Proposal for amendments to the Consolidated Resolution on the common specification of light source categories (R.E.5)

Proposal for amendment 10 to the Consolidated Resolution on the common specification of light source categories (R.E.5)

Submitted by the Working Party on Lighting and Light-Signalling*

Figure 4

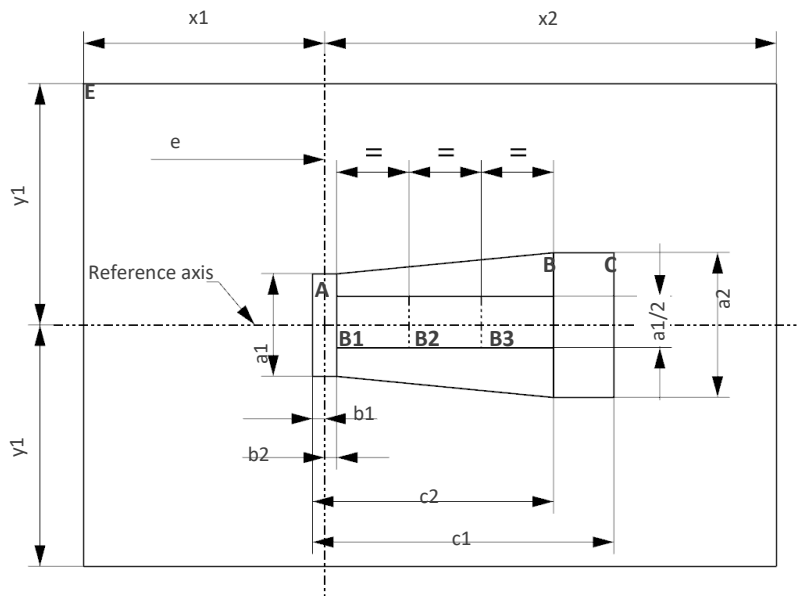
Sheet H11_LED_r/3, replace by a new sheet H11_LED_r/3, to read:

In case of Configuration-1 the position of the light emitting area is checked by a box system defined in Figure 4 when operated at test voltage, which shows the projections when viewing from B (see sheet H11_LED_r/1, Figure 1) and from A and -A (see sheet H11_LED_r/1, Figure 1), i.e. along the C-planes C₀, C₉₀ and C₂₇₀ (as defined in Figure 6).

In case of Configuration-2 the position of the light emitting area is checked by a box system defined in Figure 4 when operated at test voltage, which shows the projections when viewing from A and -A (see sheet H11_LED_r/1, Figure 1), i.e. along the C-planes C₉₀ and C₂₇₀ (as defined in Figure 6). The distance z between the surfaces of the opposite light emitting areas shall not exceed 2.9 mm.

In both configurations, the proportion of the total luminous flux emitted into these viewing directions from the area(s) as defined in Figure 4:

- Total box area: $(A+B+C) / E$ shall be not less than 90%
- Area A: $A / (A+B+C)$ shall be not more than 10%
- Areas B₁, B₂ and B₃: B_1/B , B_2/B , B_3/B shall each be not less than 15%
- Area B: $B / (A+B+C)$ shall be not less than 72 %
- Area C: $C / (A+B+C)$ shall be not more than 22%
